**Timbers at Black Forest
Letter of Intent**

February 23, 2026

Request:

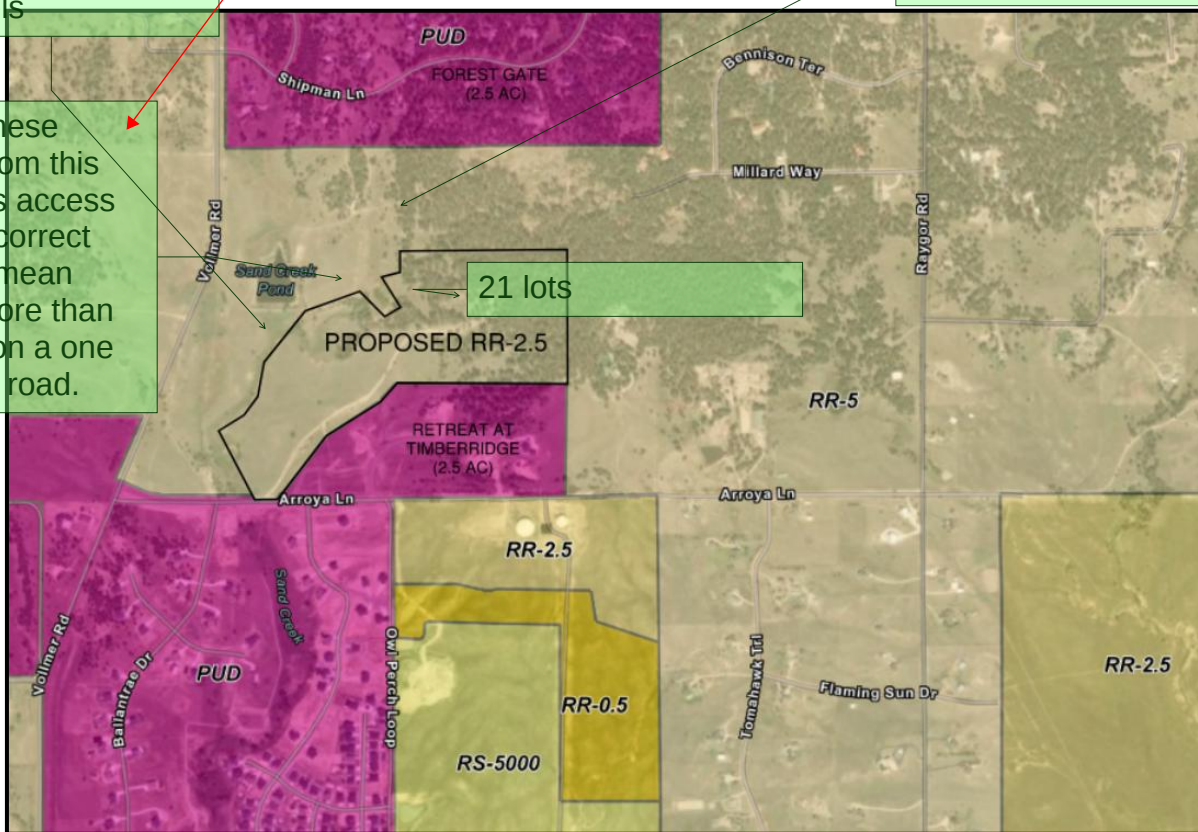
Per the applicants statement- connectivity through the site to adjacent properties should be identified as cited in LDC . The creek limits access to the west.

Access to these parcels is from this subdivisions access road today correct which may mean there are more than 25 parcels on a one lane private road.

Response: deeds and surveys were provided to EPC to clear up any confusion regarding the parcel configuration. these comments were discussed in meeting 9/1/26. the adjacent lots have access to both Arroya as well as Shipman Lane. It was determined this comment does not apply.
